ADDENDUM No. 1

PROJECT MANAGEMENT - PUBLIC SERVICES - CITY OF ANN ARBOR  
GEDES AVENUE IMPROVEMENTS  
PROJECT DETAILS  
INFILTRATION DETAILS

PROJECT MANAGEMENT - PUBLIC SERVICES - CITY OF ANN ARBOR  
GEDDES AVENUE IMPROVEMENTS  
GEDDES AVENUE TYPICAL SECTIONS  
P.O.B. TO 23+75

PROJECT MANAGEMENT - PUBLIC SERVICES - CITY OF ANN ARBOR  
 GEDDES AVENUE IMPROVEMENTS  
 STORM SEWER PLAN AND PROFILE  
 ST. 10+00 TO STA. 14+50

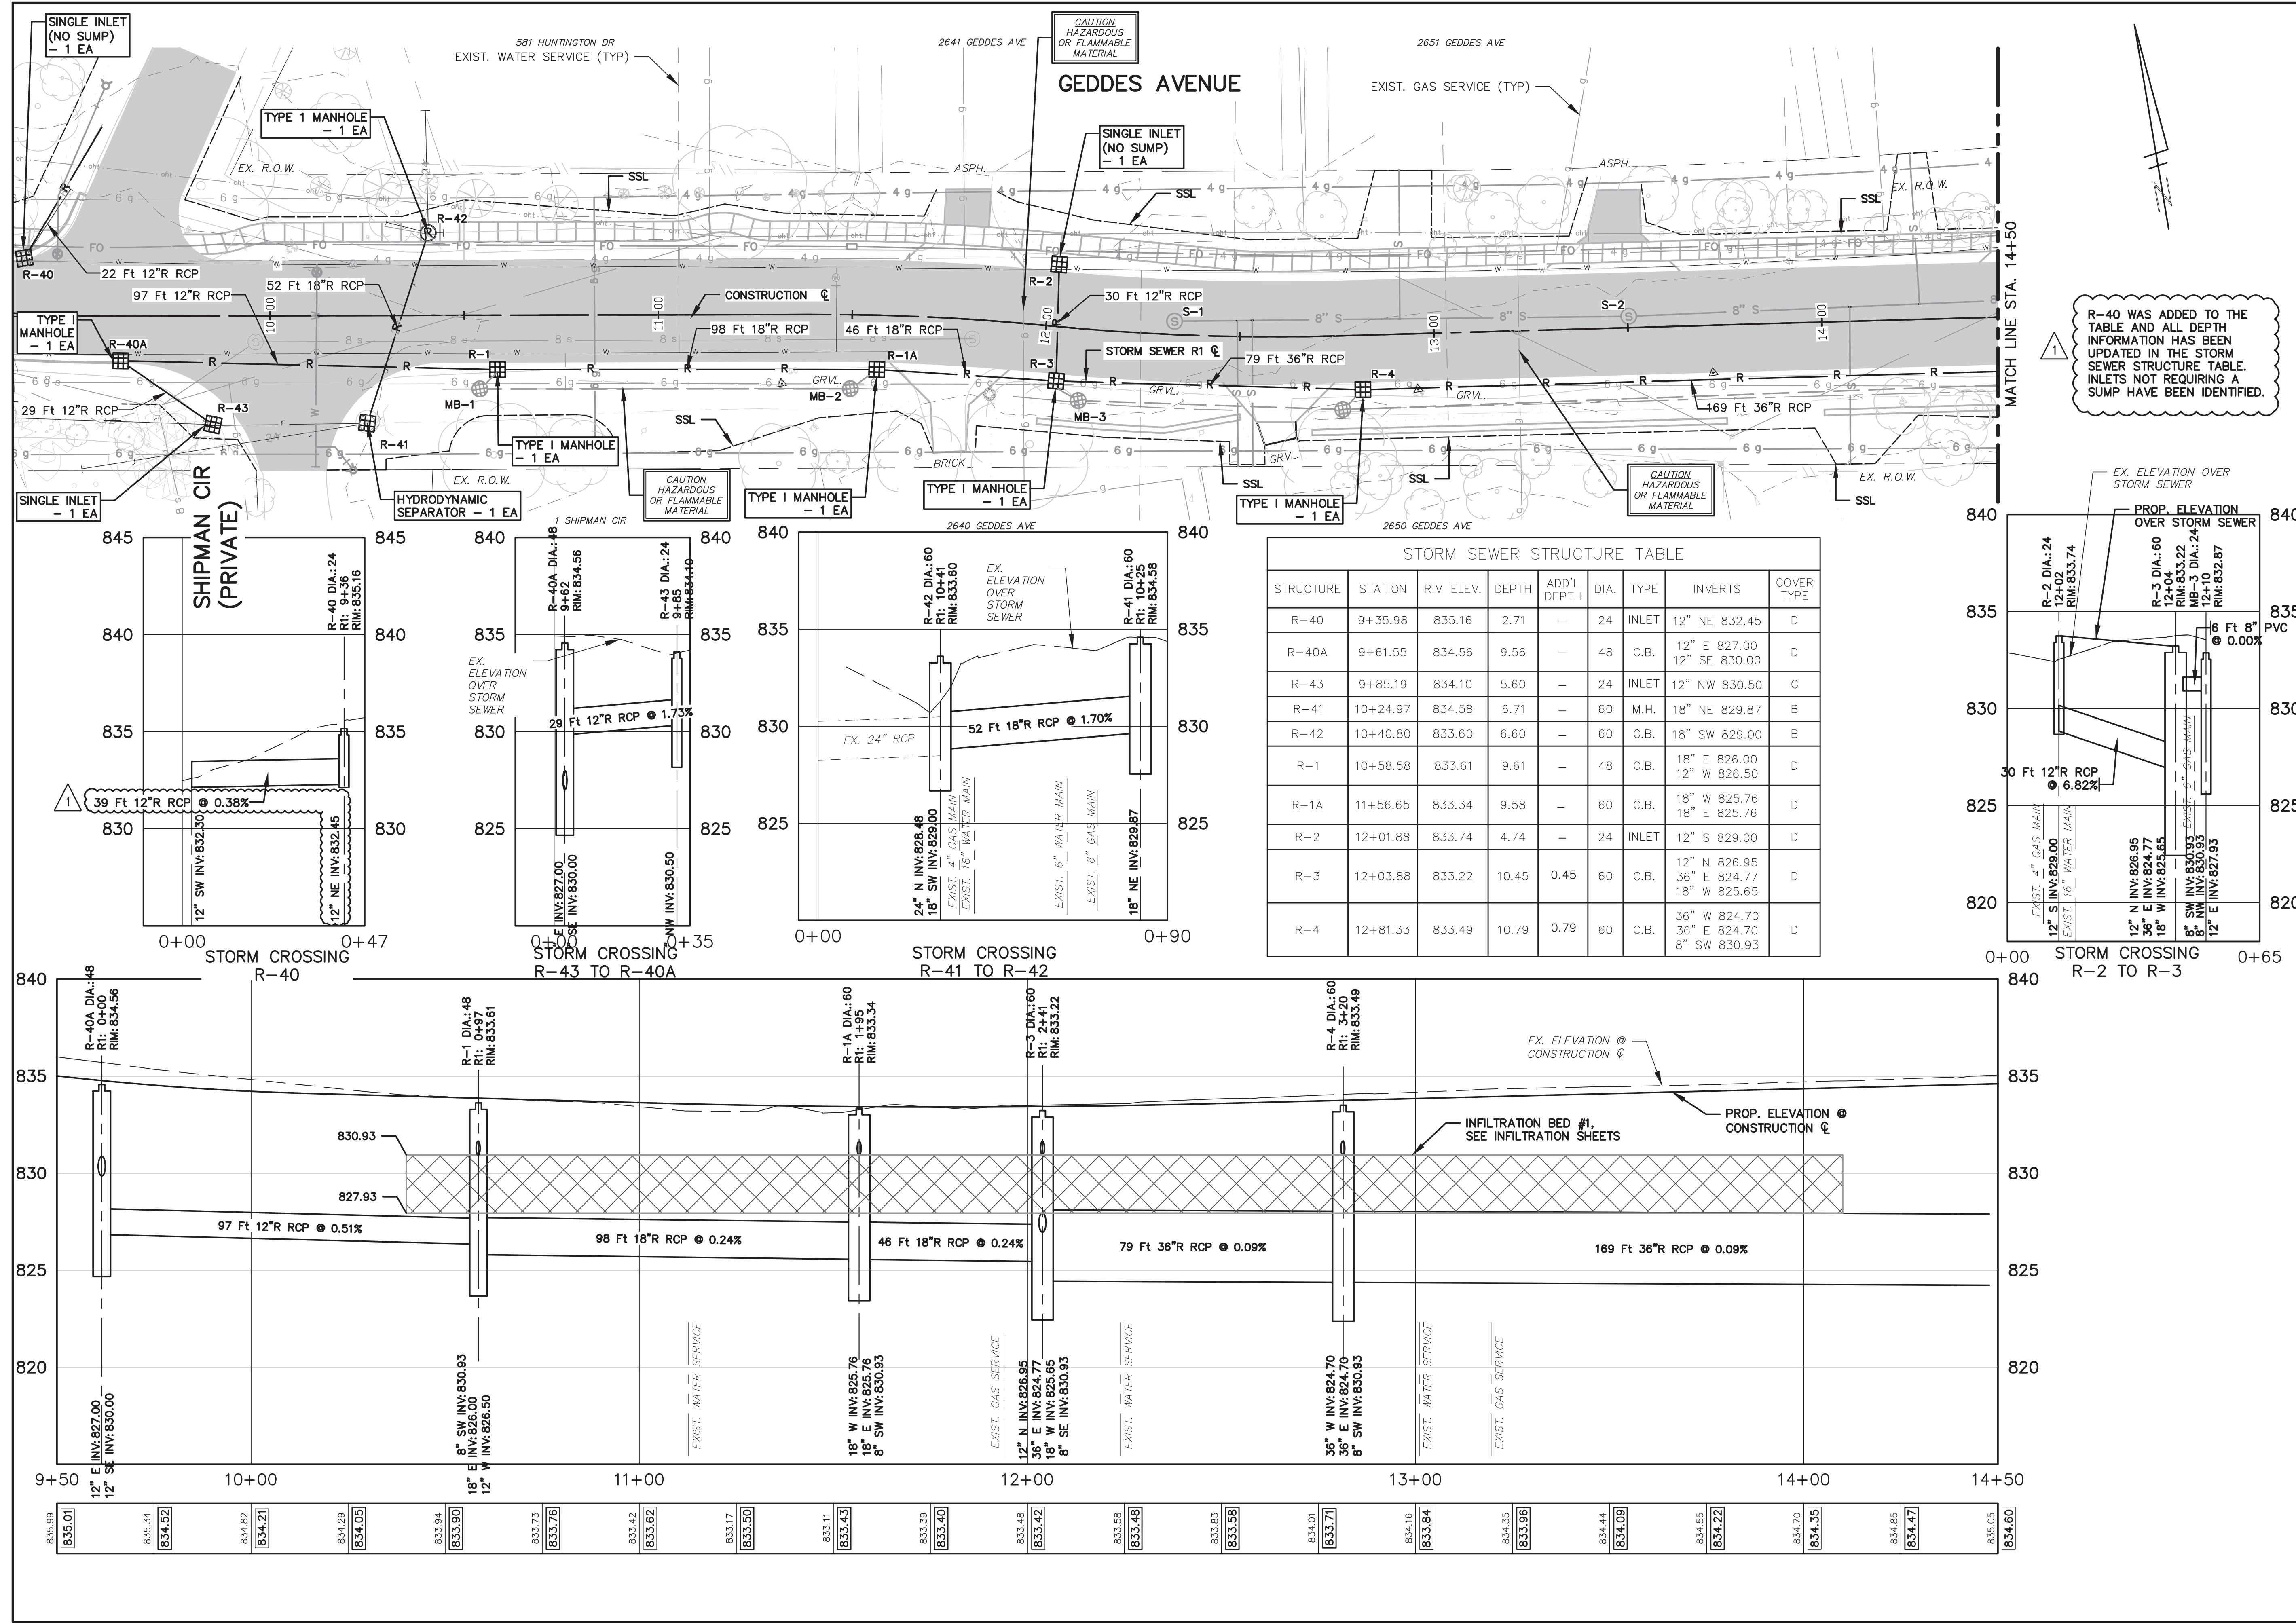
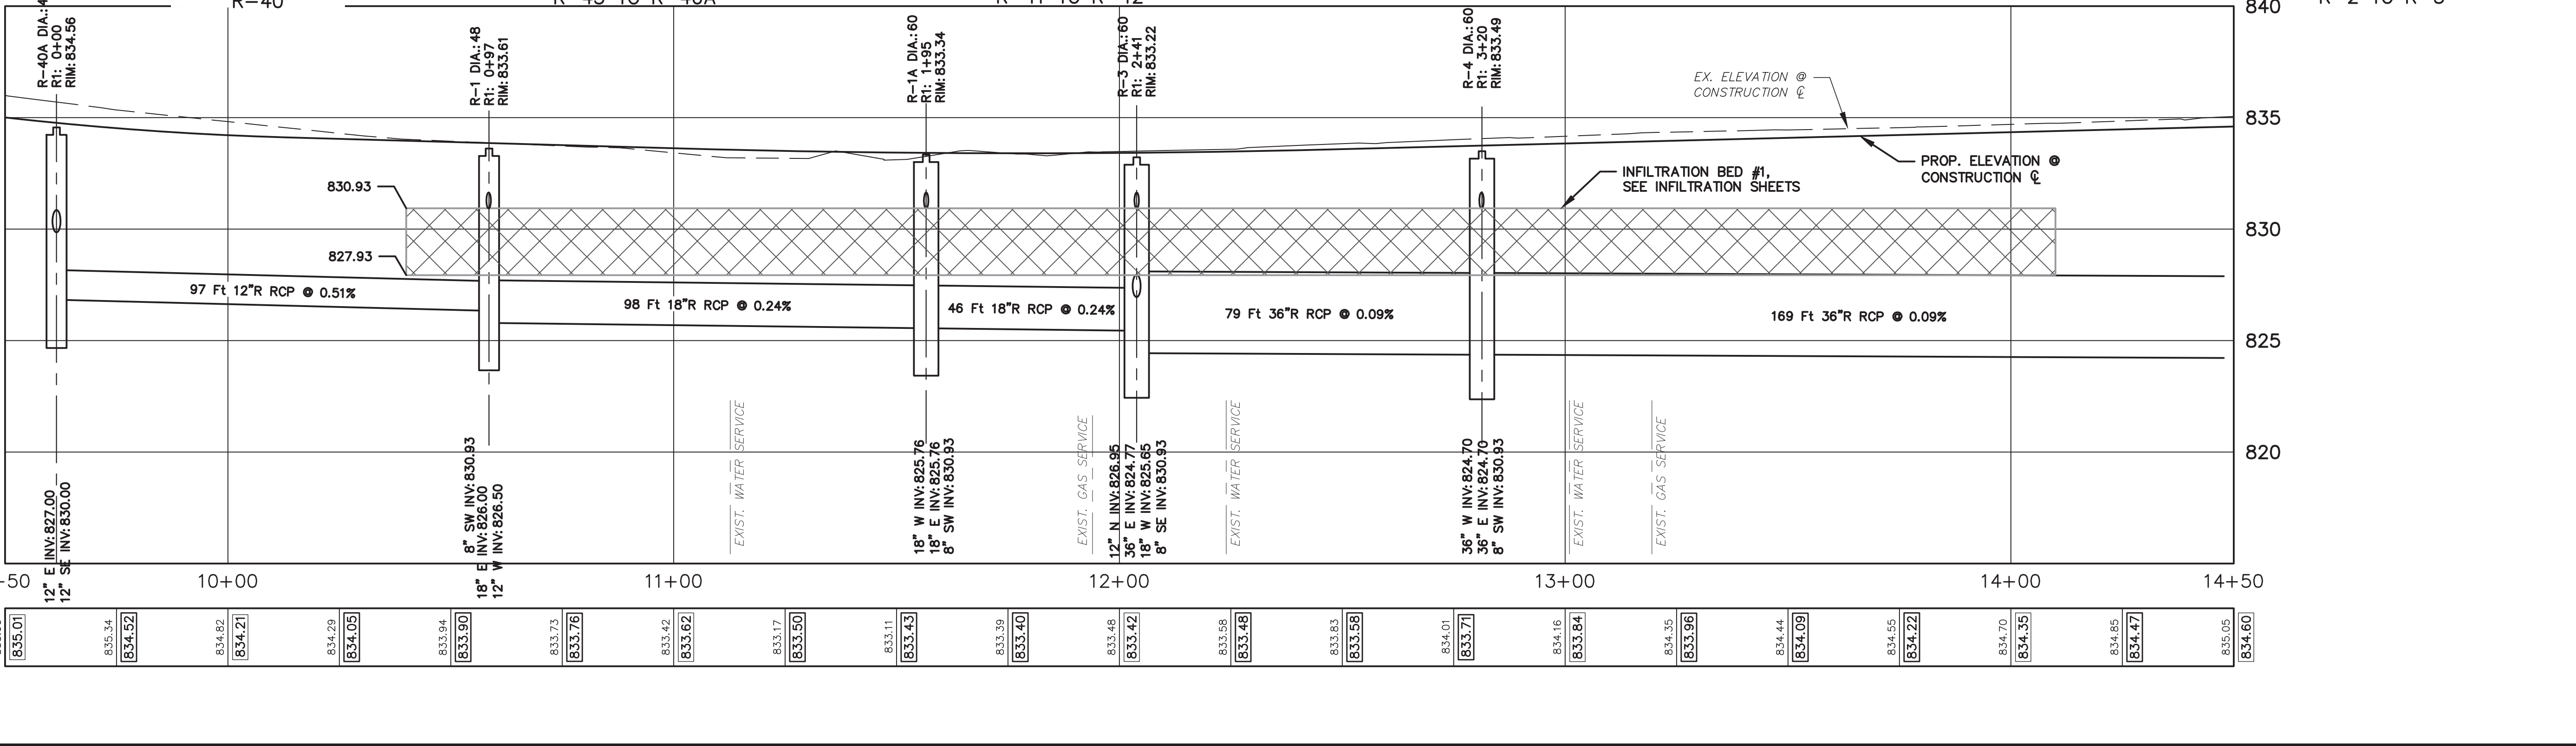
R-40 WAS ADDED TO THE TABLE AND ALL DEPTH INFORMATION HAS BEEN UPDATED IN THE STORM SEWER STRUCTURE TABLE. INLETS NOT REQUIRING A SUMP HAVE BEEN IDENTIFIED.
